1501 SOUTH STREET 1 MARKET-RATE UNIT

Building Permit Allocation System (BPAS) Application

RE: Request for Market Rate Building Permit Allocation System Allocations for 1501 South Street, Key West, Florida 33040

CITY OF KEY WEST, FLORIDA PLANNING DEPARTMENT

SITE PLAN

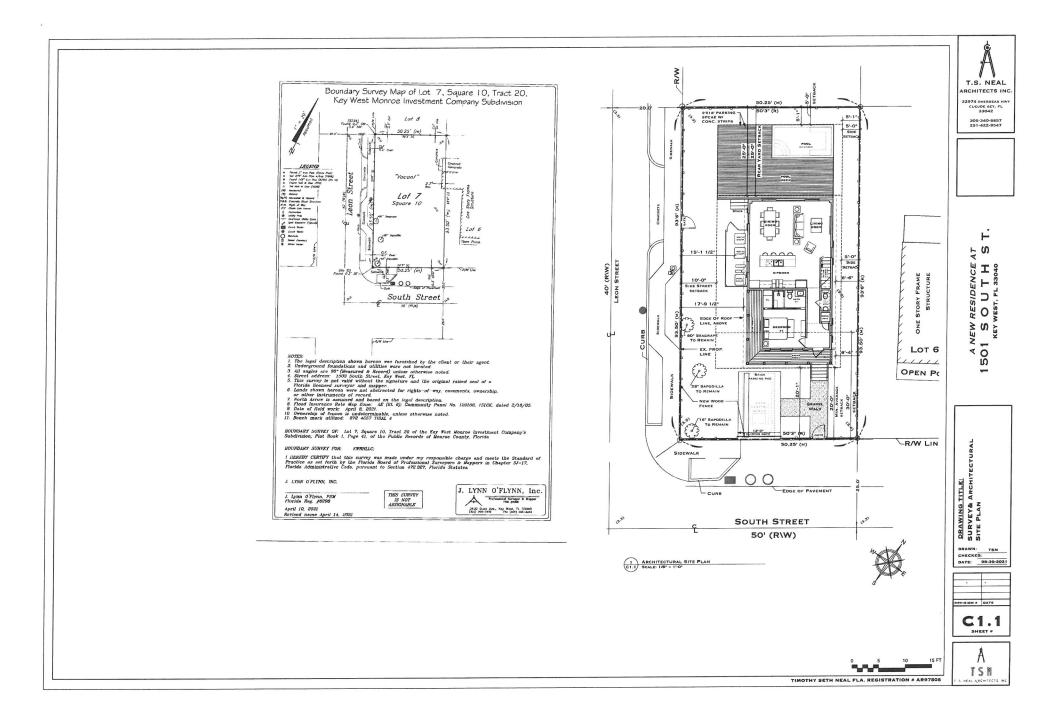
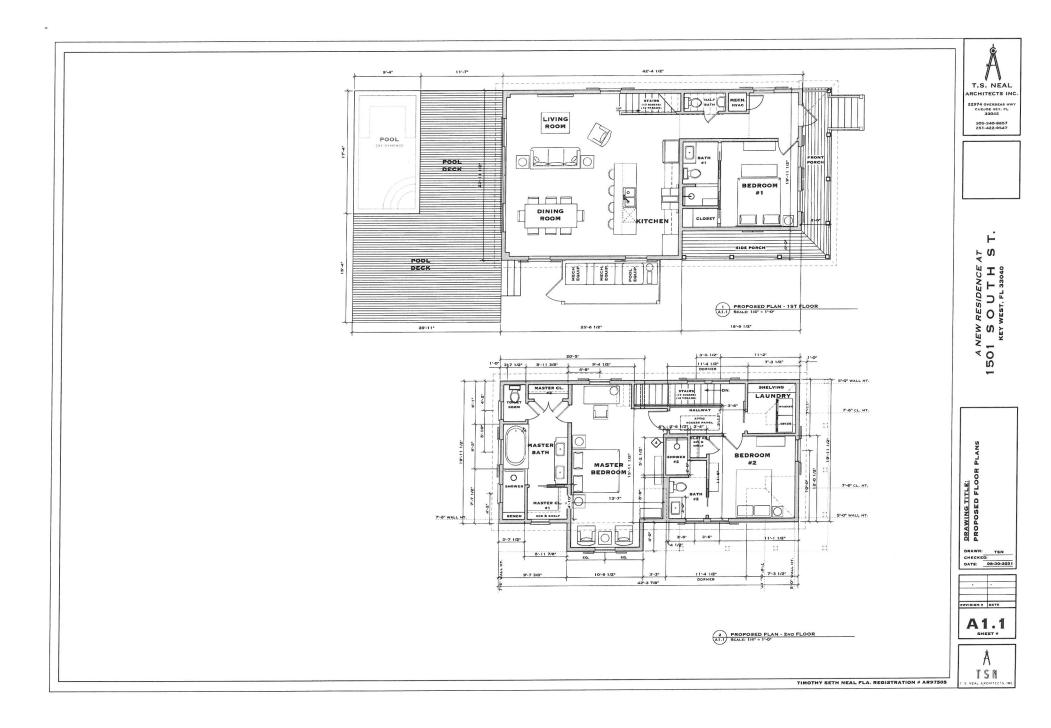
Status: Site Plan A2.1 (page 31/34) shows the 1st level finished floor at 7', which is 1' above the BFE. The parcel is in the AE-6 flood zone. Unverified.

Status: Site Plan A2.1 (page 31/34) shows the 1st level finished floor at 7', which is 1' above the BFE. Unverified: no points awarded.

Applicant Action: To qualify, the first habitable floor must be 1.5' above the BFE. Please update plans and resubmit.

Applicant Action: To qualify for the points, please provide revised plans that meet the requirement.
